JACK LONDON
PARK
PARTNERS

Re: Notice of Preparation for the Eldridge Renewal Project at the Sonoma Developmental Center

Exhibit 2: High-level summary of potential Project impacts and appropriate alternatives

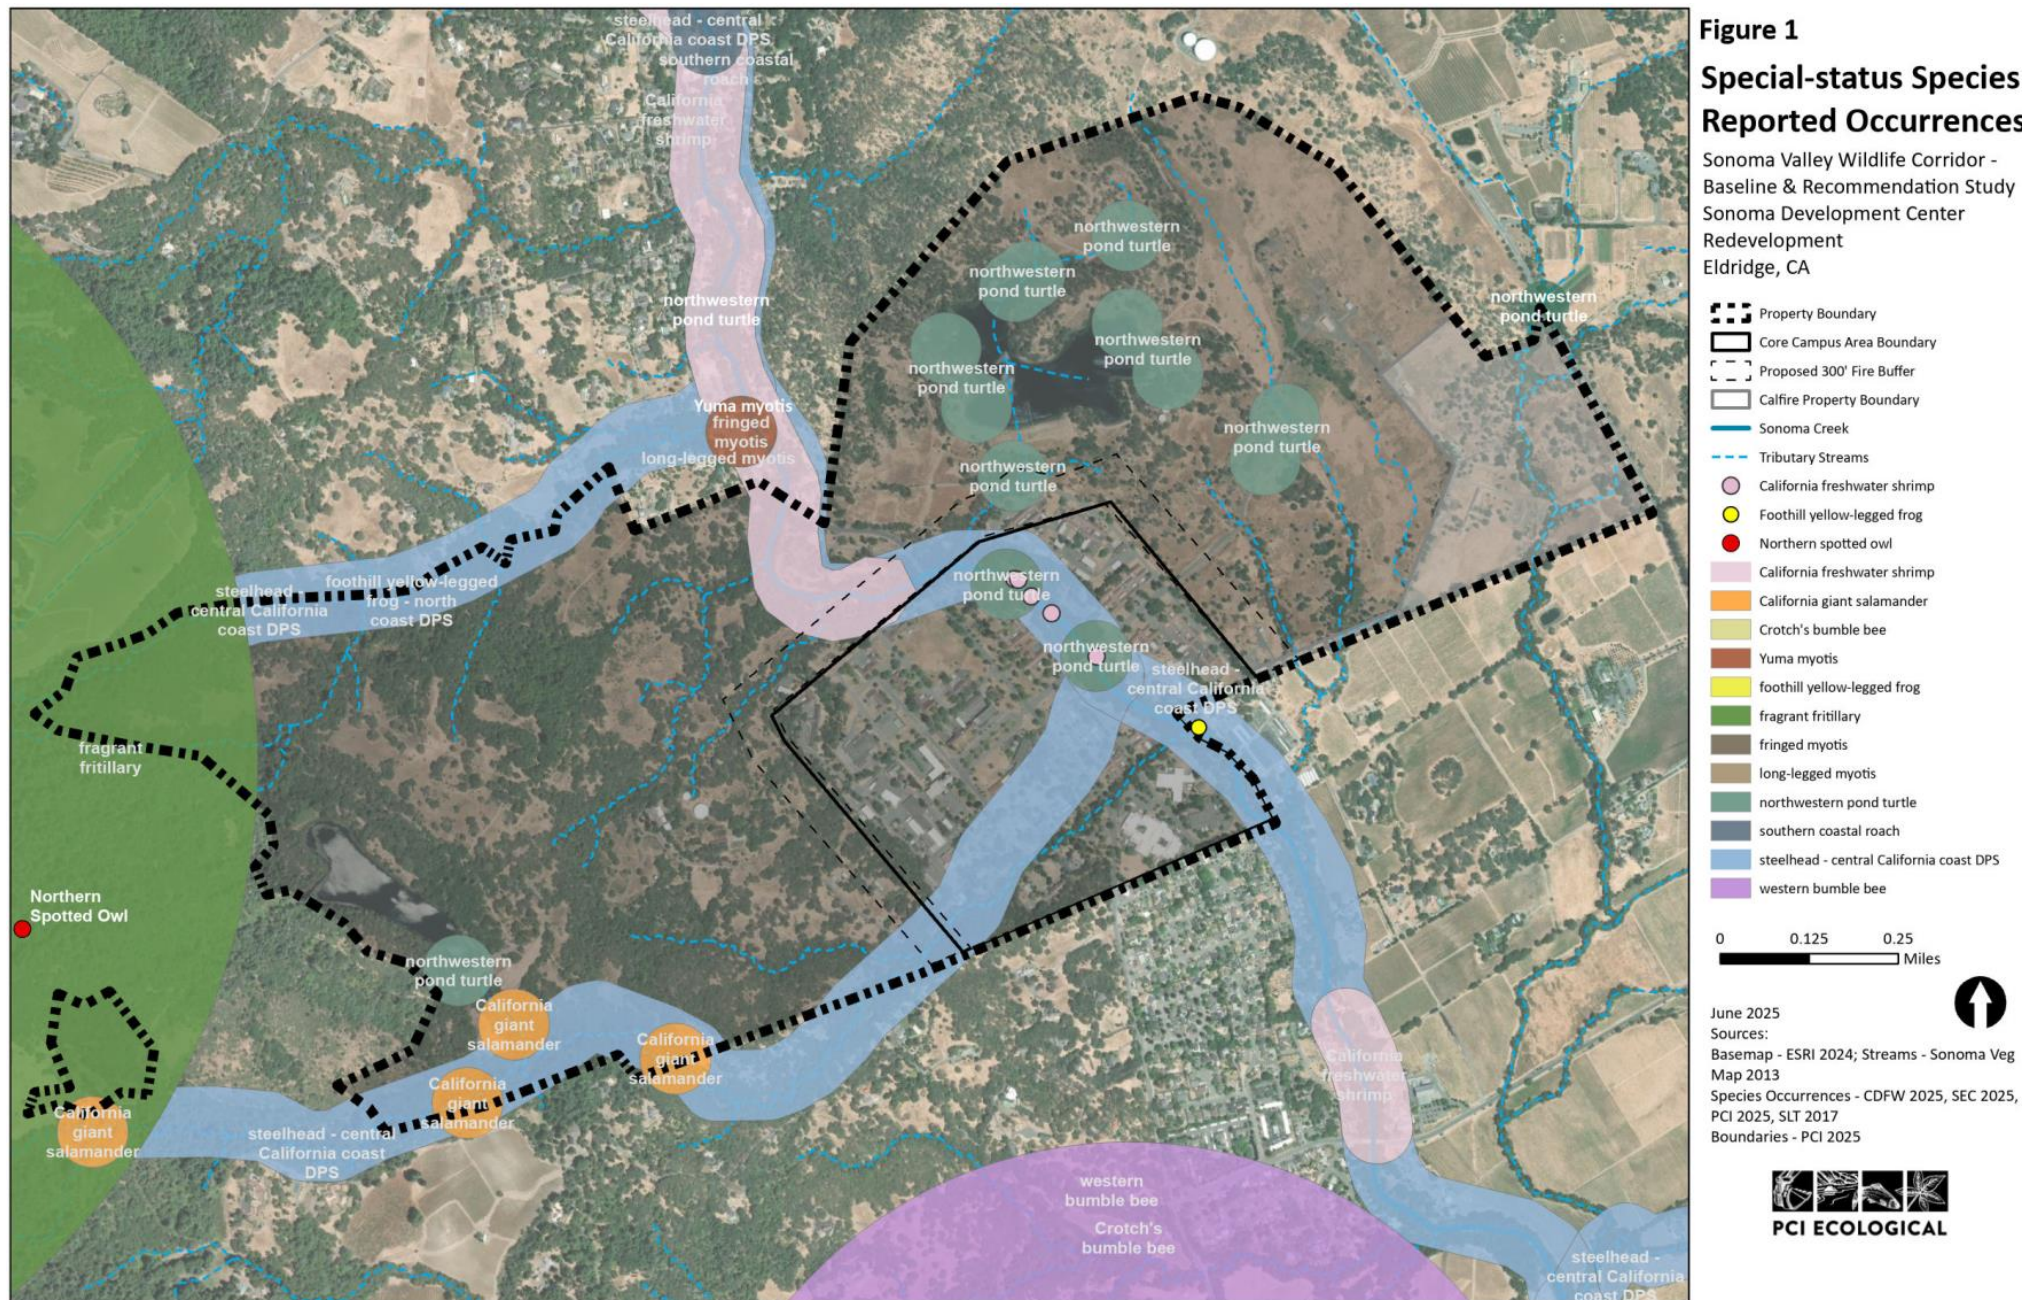
Presence of special status species in waters to be altered by the Project Roulette Springs is a year-round “spring complex” located amongst forest/wetland vegetation, northeast of Fern Lake. It then flows 0.21 miles, joins Asbury Creek, and runs another 0.64 miles into Sonoma Creek. Water diversions from Roulette Springs ceased in 2018 when the SDC water treatment plant was shut down. Since then, Asbury Creek, which ran completely dry by late June in recent years/decades, has become a perennial creek again, at least from the Roulette Creek tributary down to Sonoma Creek. Historically a steelhead-bearing stream, but without evidence of anadromy for decades, observations of steelhead in Asbury Creek have recently been made by Sonoma Ecology Center just 6-7 years after the return of perennial flow. It is presumed that other protected species like California freshwater shrimp might eventually return to Asbury Creek, or utilize it for part of the year (red-legged frog) as well, if they haven’t already. **See Figure 1, Exhibit 3.**

Figure 2. Special-status species reported occurrences at the Sonoma Developmental Center. There is additional suitable habitat for protected species on the SDC, especially in waterbodies (Fern, Suttonfield, Asbury, Mill Creek) that are part of the proposed water system (see Figure 1).

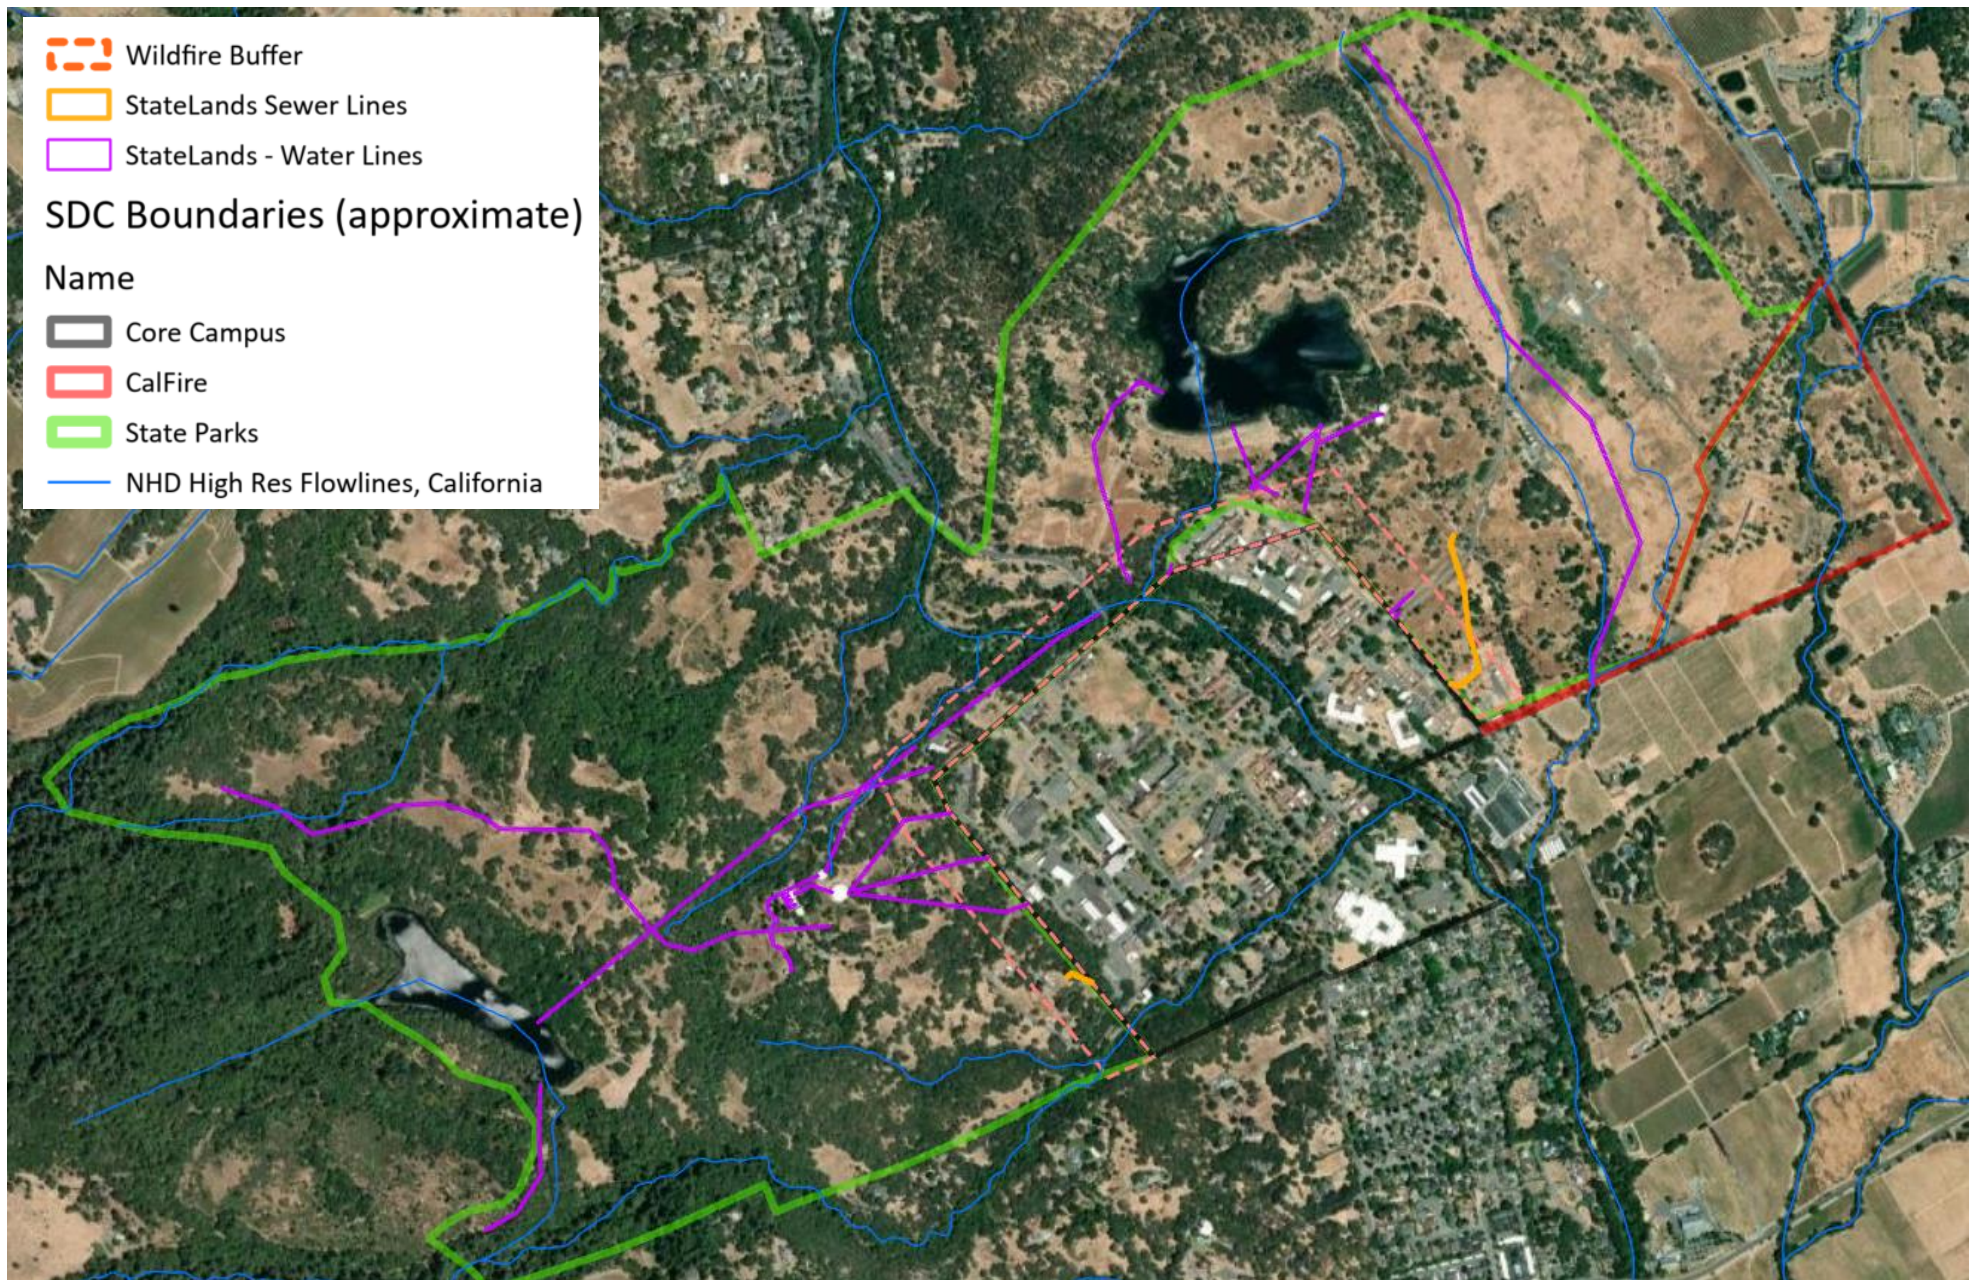
Although it is difficult to determine specific impacts, due to the limitations in the description of the Project, there are many special status species present within the area where the Project proposes activities. Figure 1 and 2, Exhibit 3

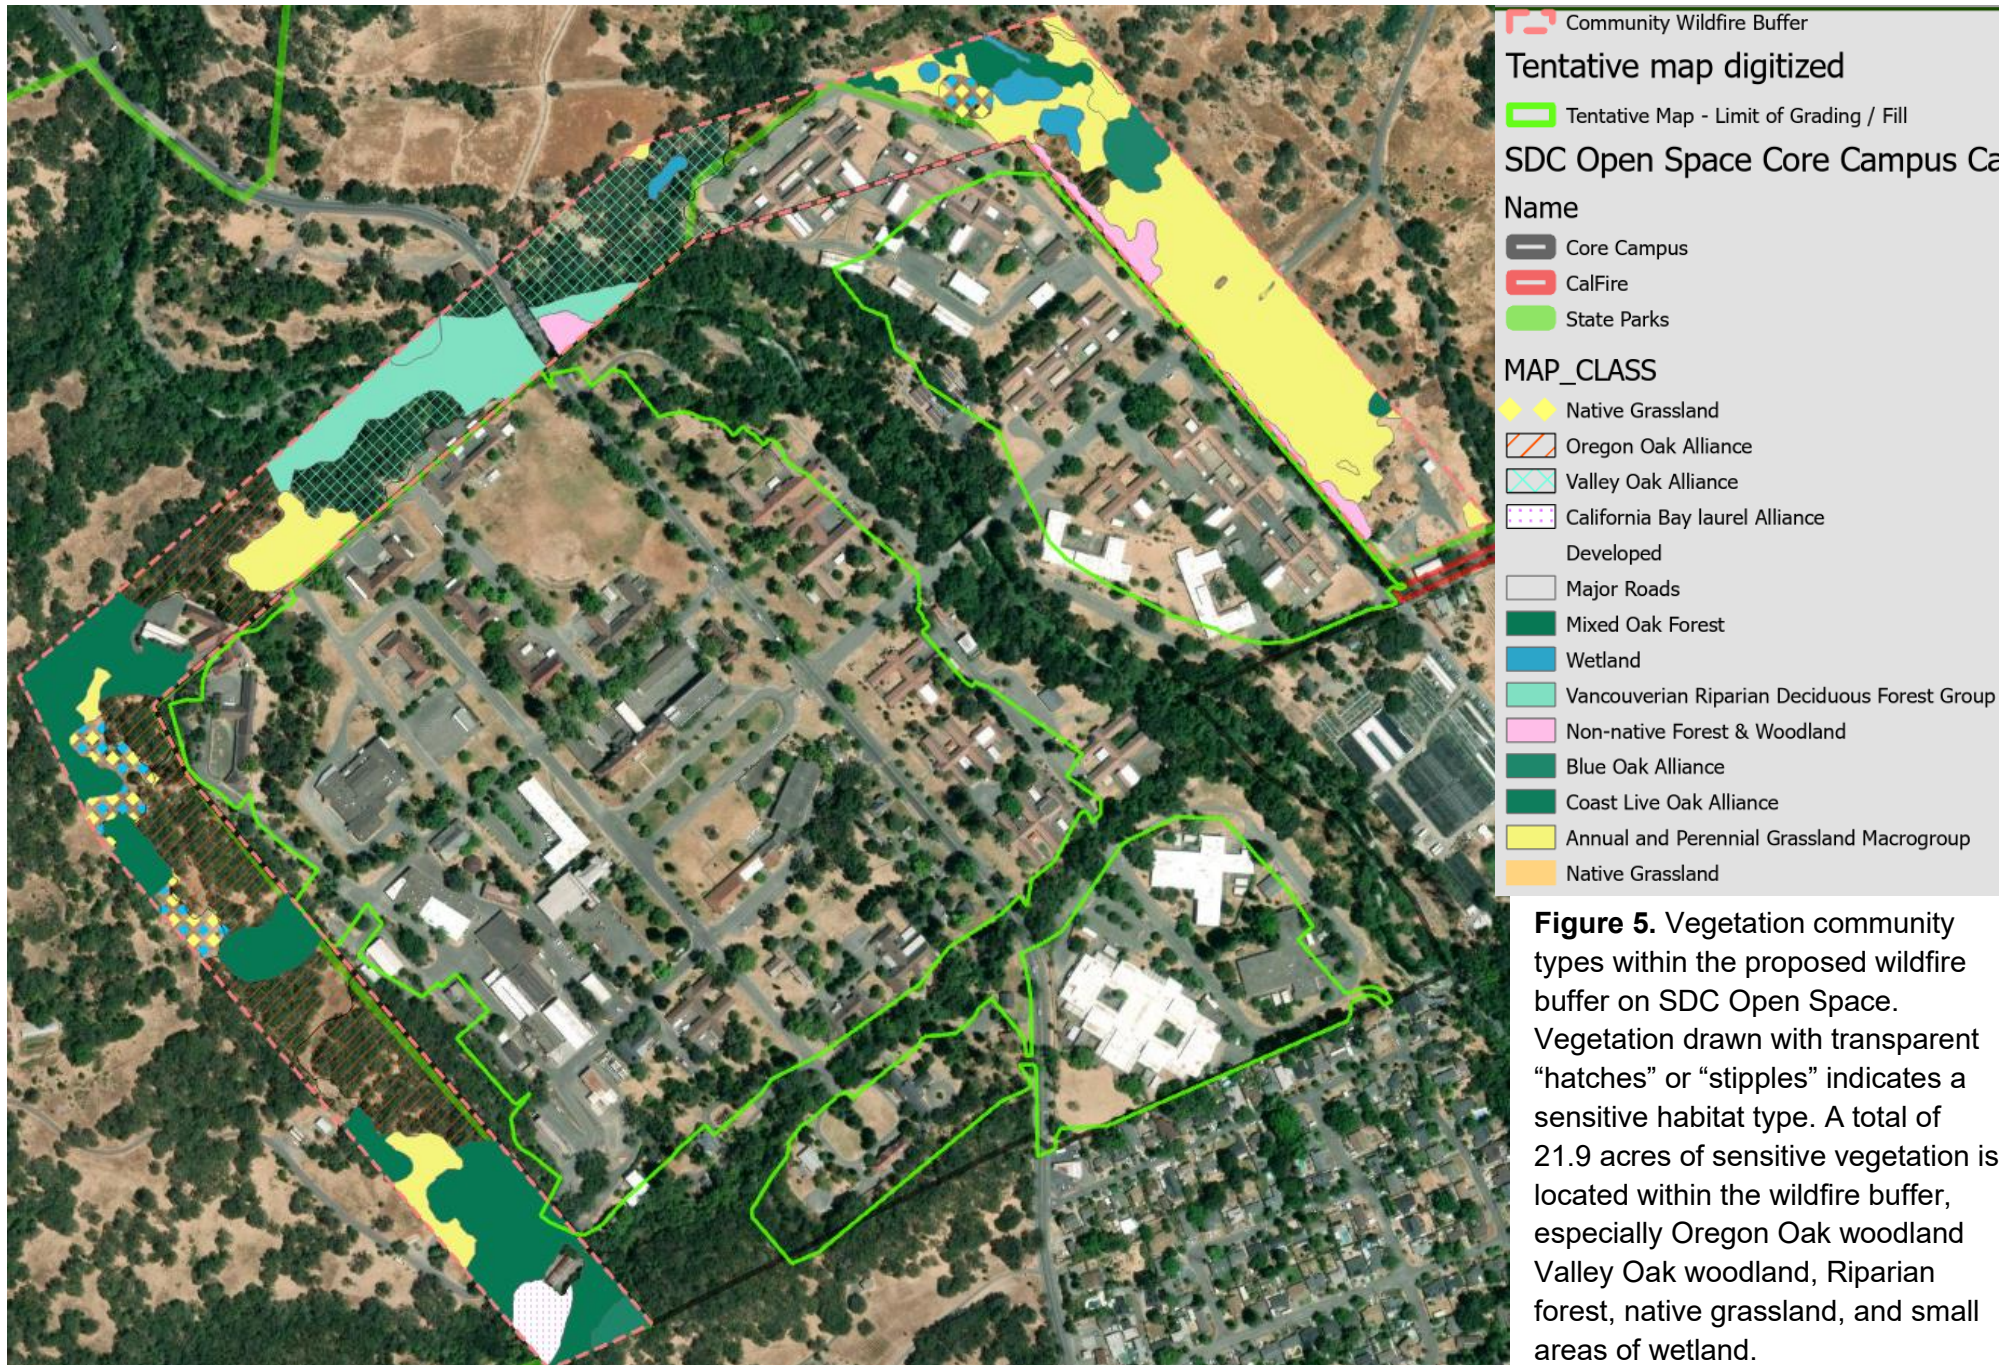
There are a few locations where habitat removal during grading is most egregious, and avoidable. First, the Project proposes ~27 homes along the South and West edges of campus, outside of the zone of previous development. Not only does the placement of these homes remove native forest through grading, it also increases fire risk, fire exposure, increases impacts on wildlife habitat and connectivity, and reduces the scenic resources of the site. Second, in one location (along Sonoma creek, on Railroad street), the Project proposes removal of ~1 acre of Valley Oak forest, placement of ~1 acre of fill into a stream channel, for the sake of building 3 homes along the creek. Furthermore, the Tree Protection Plan (NOP Figure 11) does not seem to address forest removals in these 2 most egregious locations, missing almost 2 acres (see Figure 4 to Figure 6 for maps and additional tables, Exhibit 3).

After subtracting out sensitive habitat types, our analysis found that grading **removes another 15.4 acres** of vegetation on the Core Campus, largely composed of non-native forest and mixed oak forest types. Another **27.85 acres would be potentially degraded** (or modified) by wildfire buffer management, re-constructing the water/sewer system on State Park lands, and by enclosing intact vegetation into backyards. Figure 4 to Figure 6, Exhibit 3

- Adoption of additional best practices related to Artificial Light and Noise (follow Dark Sky International’s Responsible Outdoor Lighting Guidance).
- Update Arborist report to include ALL areas planned for grading / tree removal, including the approximately 2 acres of sensitive vegetation currently missing.

Figure 13. Showing proposed storm drain system, in relation to riparian setbacks, from Tentative Map.

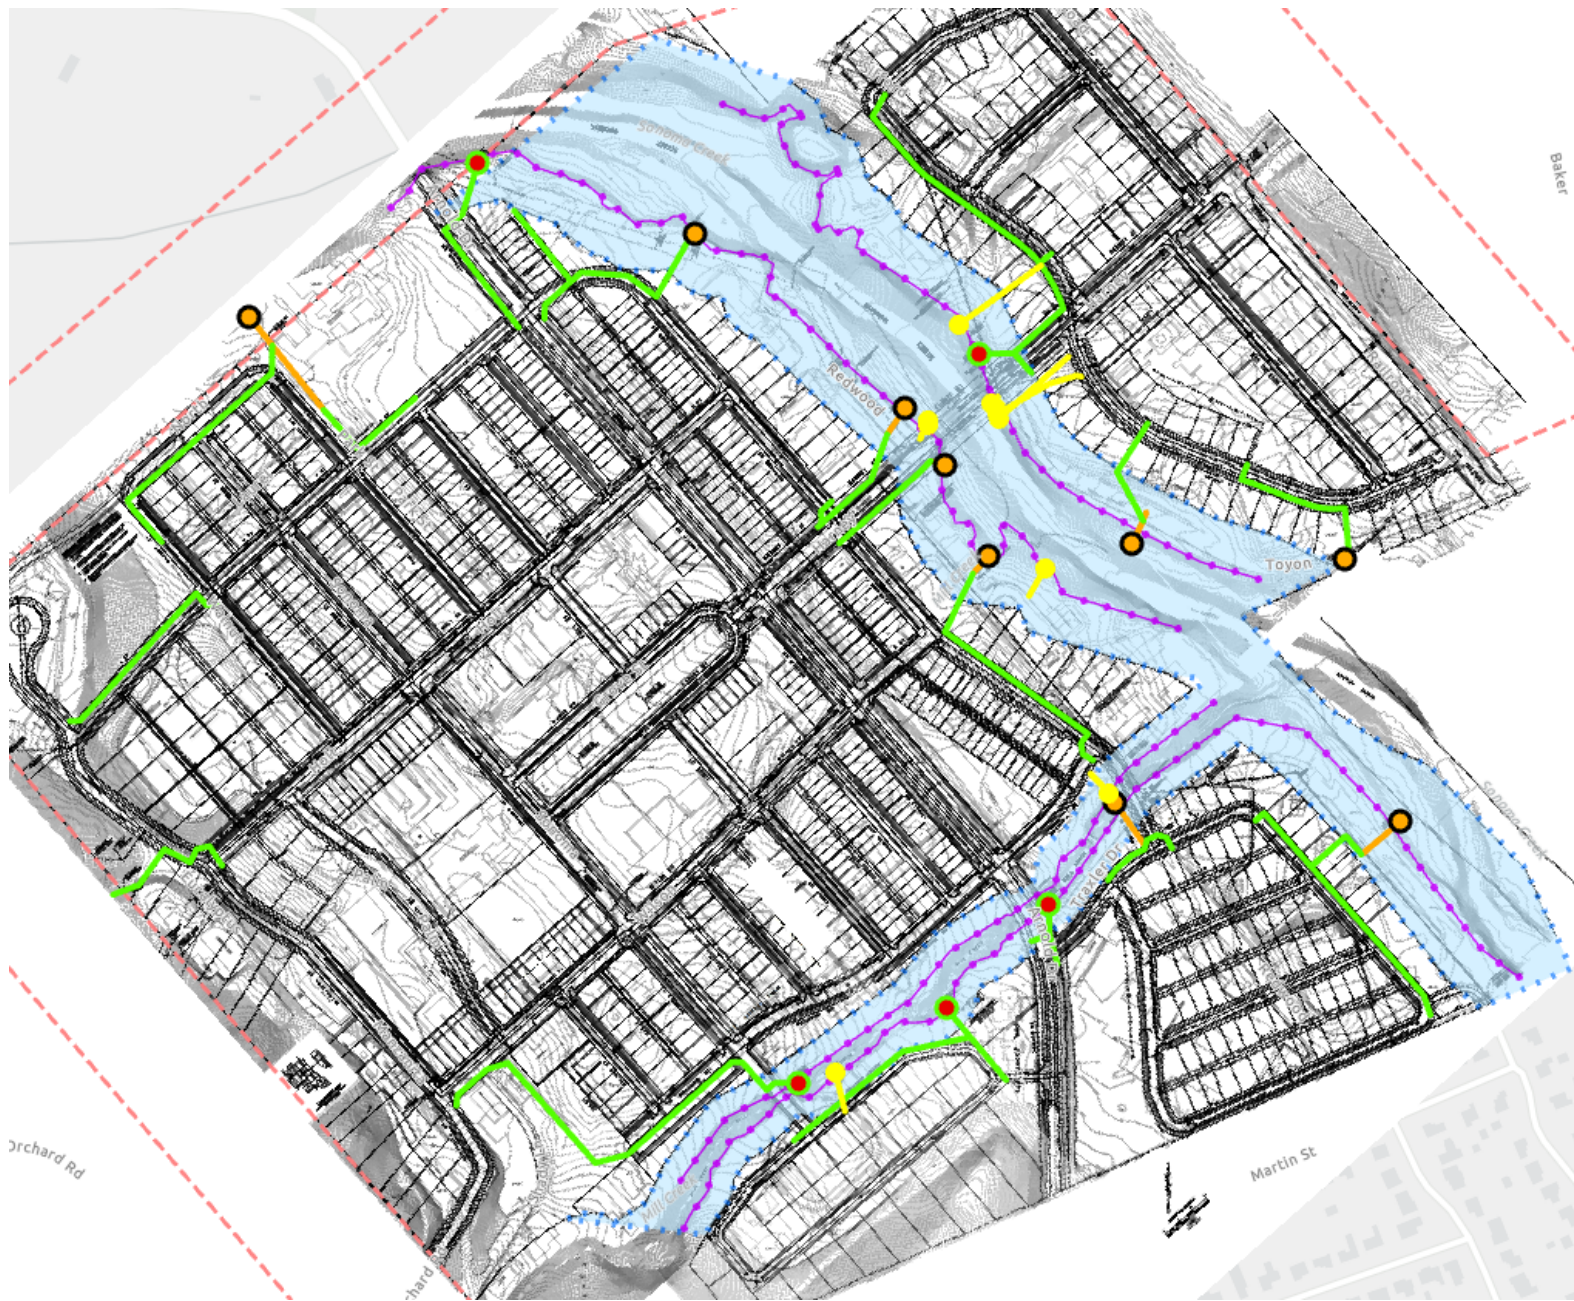
Map shows 5 new outfalls, located within top of bank.

Some proposed (existing or new) outfalls already have erosion issues.

The Project could exacerbate erosion by putting more water into fewer pipes, during the operation of the Project, and impact habitat quality for special status species in creeks. The Lead Agency should consider Alternatives that treat stormwater with multiple methods, and avoid areas of existing erosion.
